**Addendum No. 7  
January 14, 2019**

**Anna Rockwell Elementary School  
Renovations & Additions  
400 Whittlesey Drive  
Bethel, CT 06801  
State Project No. 009-0058 RNV  
Phase 1 of 2**

**ADDENDUM #7**

**ANNA H. ROCKWELL ELEMENTARY SCHOOL**

**1. 09 66 23 – EPOXY TERRAZZO**

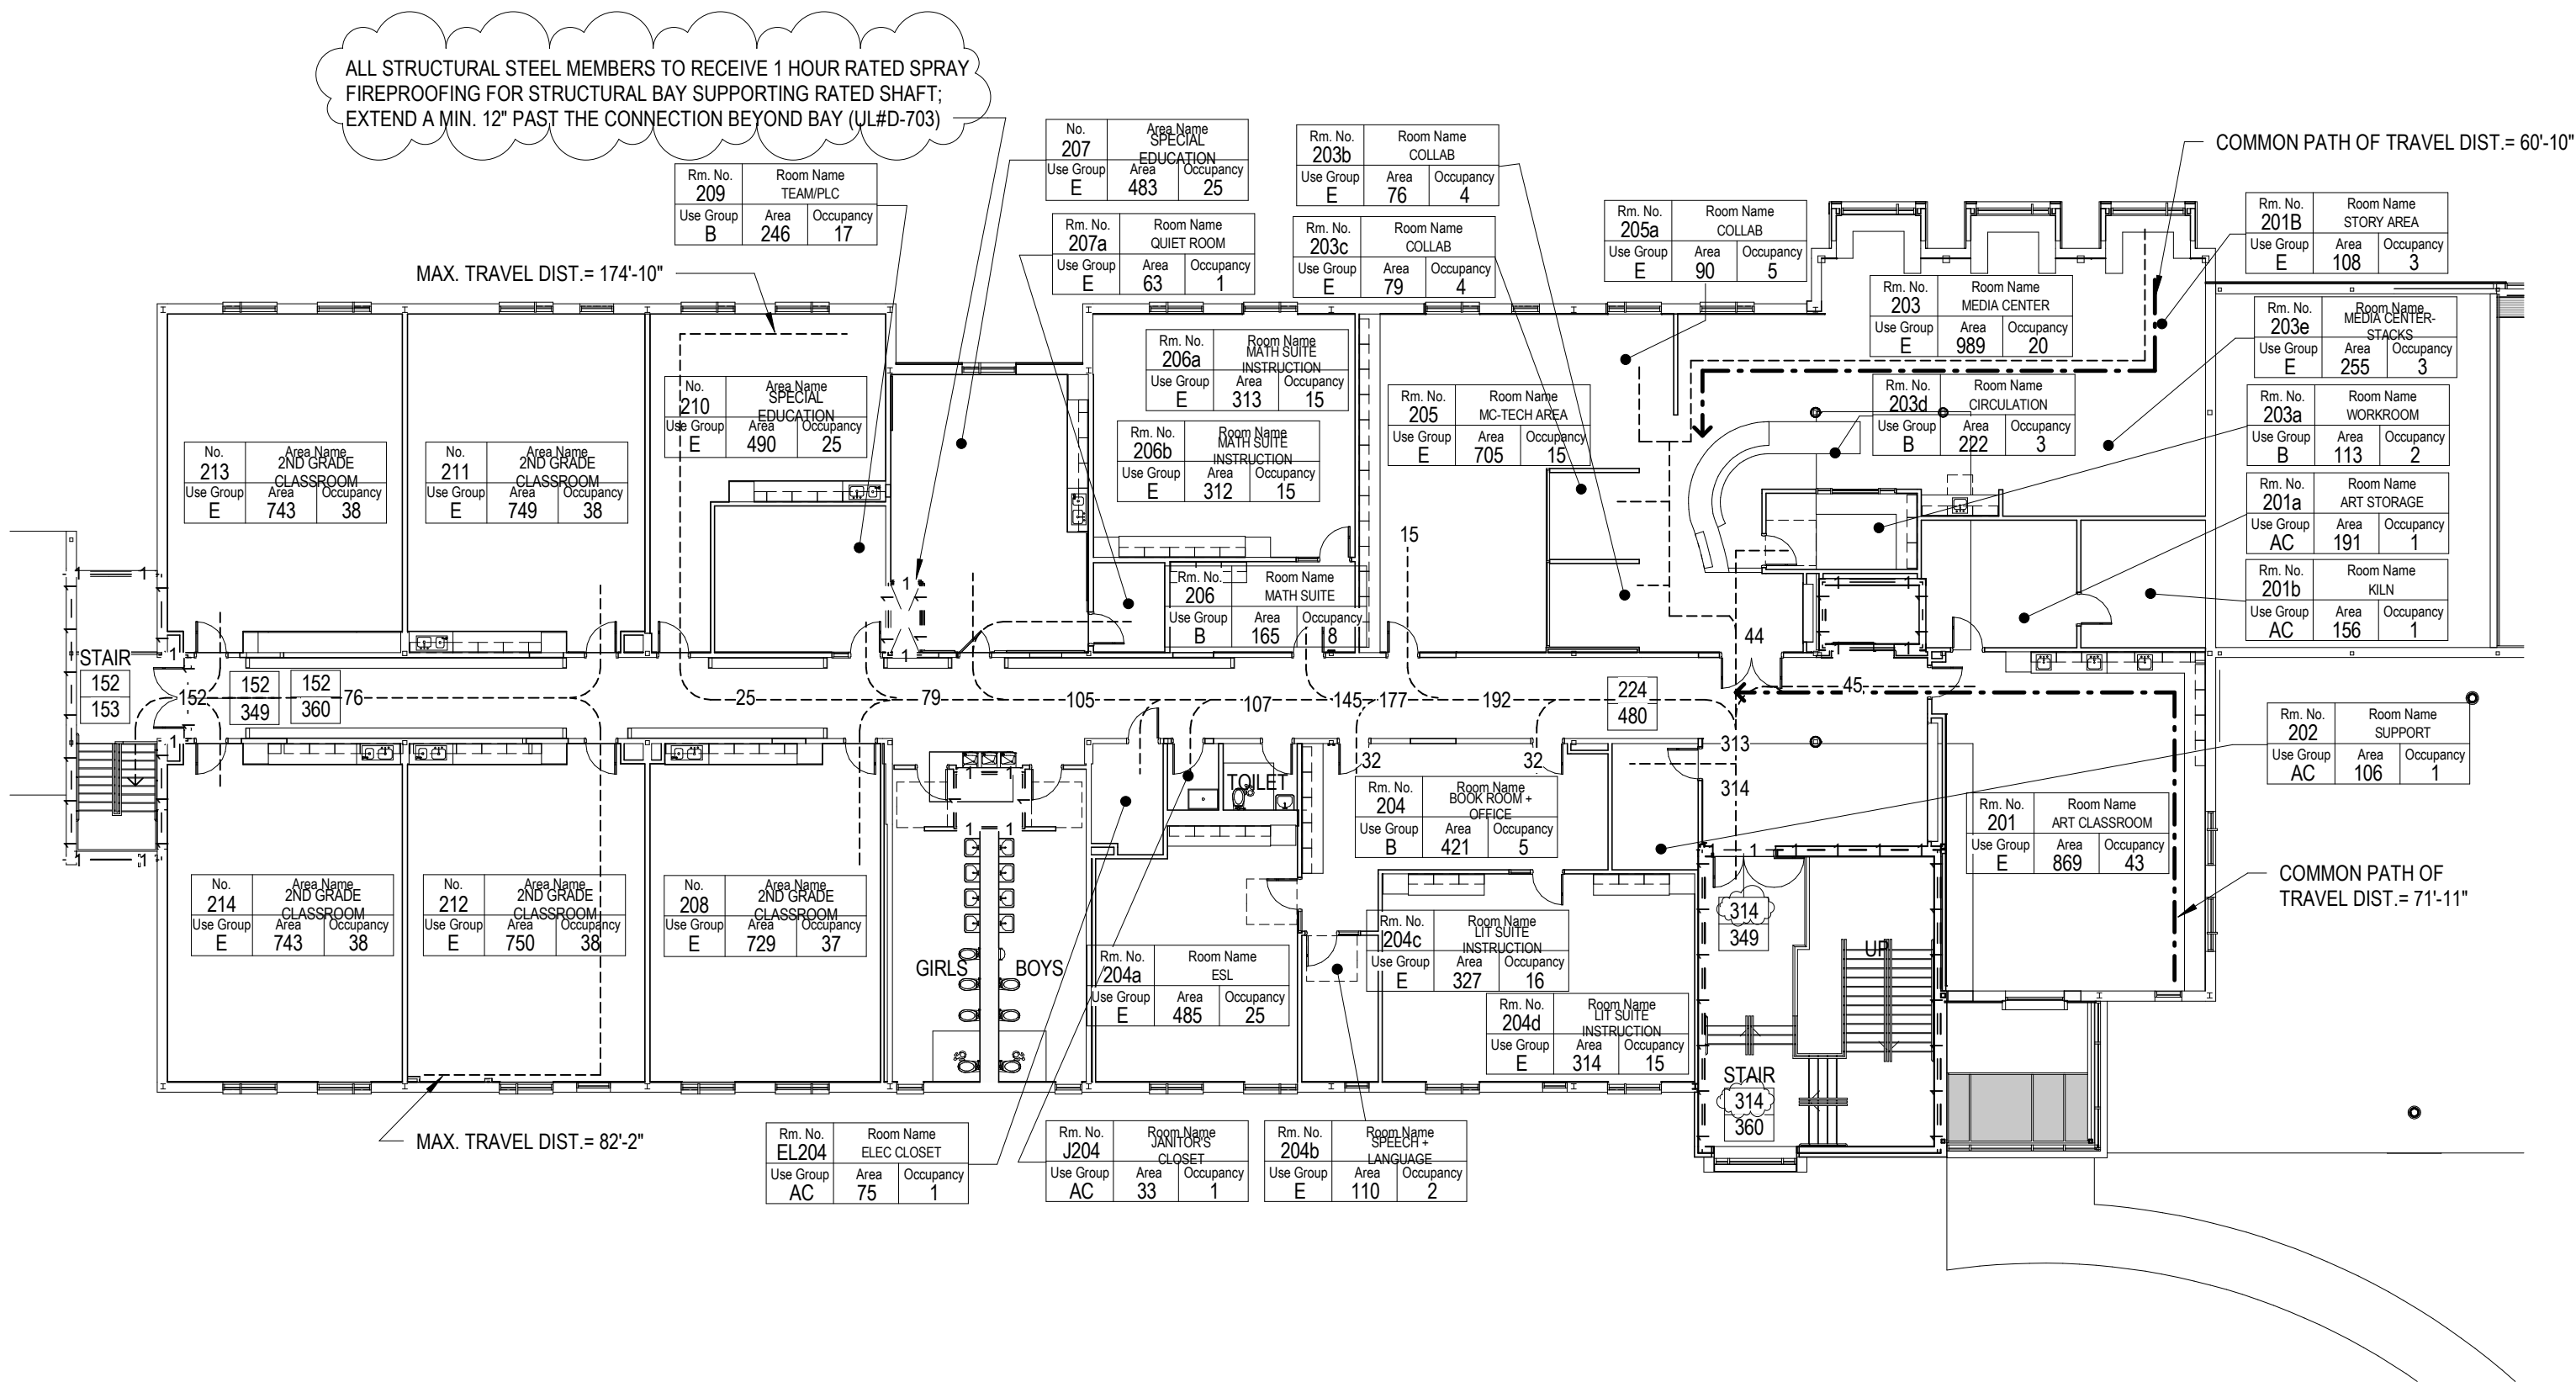
ADD Line 9. To Article 2.02 A. to read as follows: "Terroxy Resin Systems"
